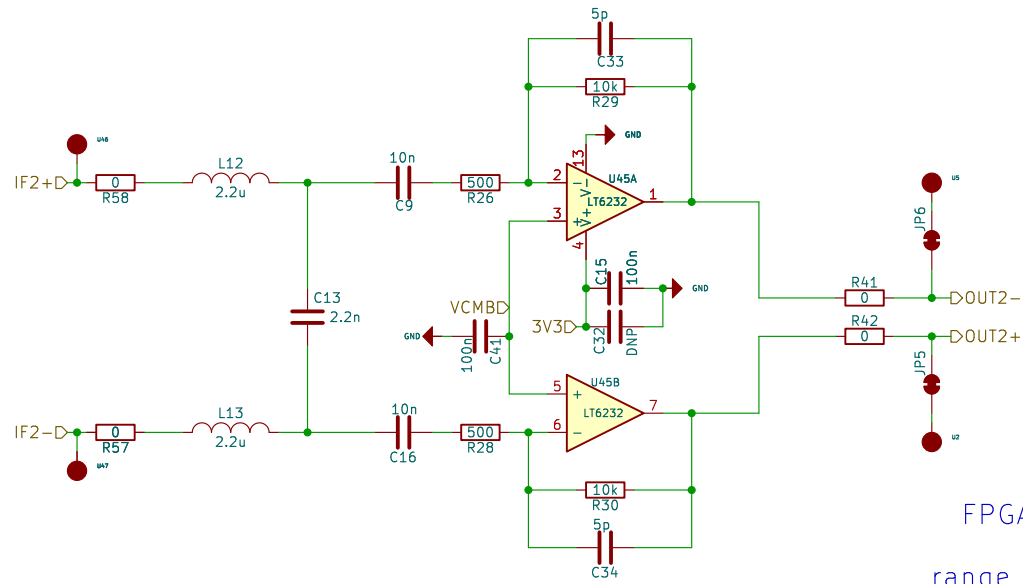
FPGA FIR Filter works perfectly.  
Second stage for HPF  
range compensation filter is removed

Sheet: /opamp\_amp/  
File: opamp\_amp.kicad\_sch

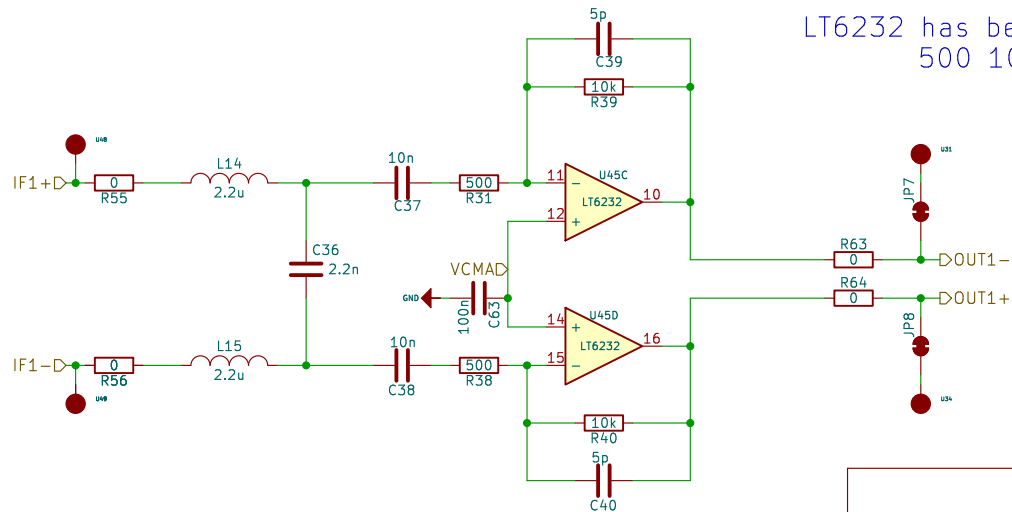
LT6232 has better noise performance as  $1.1\text{nV}/\sqrt{\text{Hz}}$   
500 10K has less noise contribution

| Sheet: /rx1/<br>File: rx.kicad_sch |          |      |

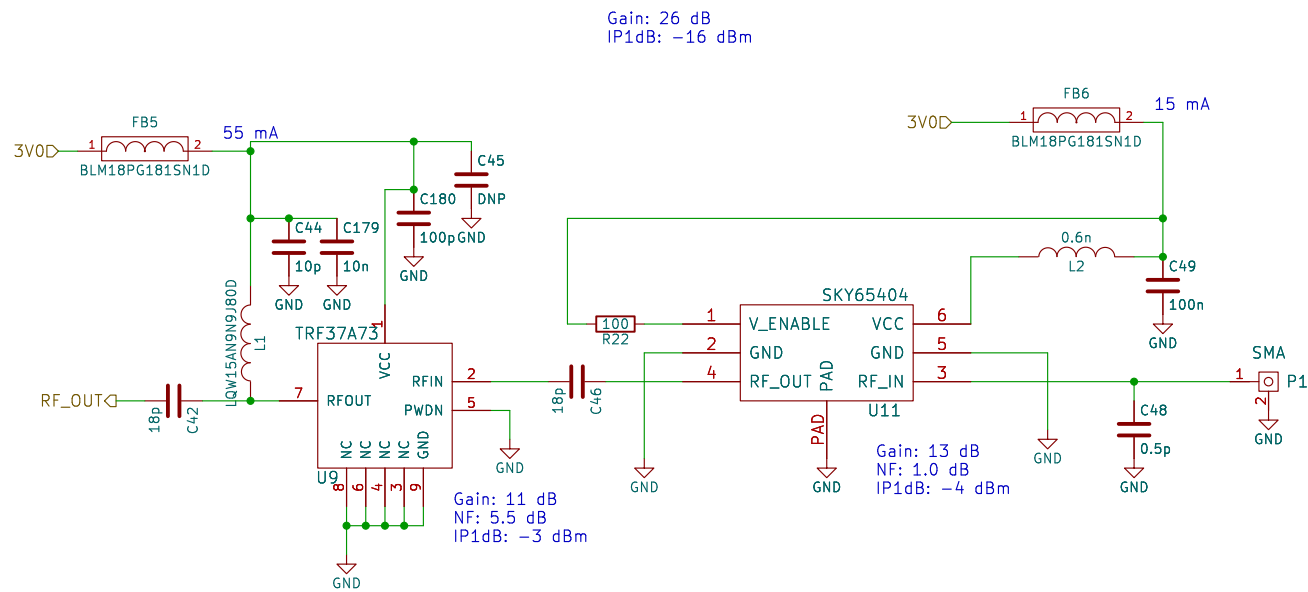
10V current: 1mA  
3.3V current: 35mA  
3.0V current: 27mA  
5V current: 750mA

Gain: 32 dB  
34dBm P1dB  
650mA current 25dBm output  
750mA current 28dBm output

3.0V current: 70mA

Sheet: /clock/  
File: clock.kicad\_sch

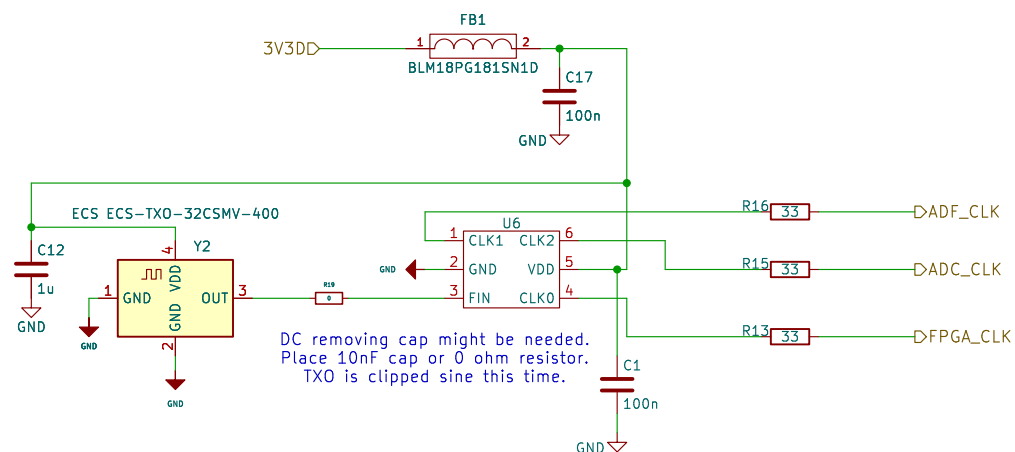
This is the prev design:  
NB3N551 is obs.  
Also this txo is generating pure sin.  
ADC might need cmos like input not sin.  
That could be the reason of duty stabilizer.
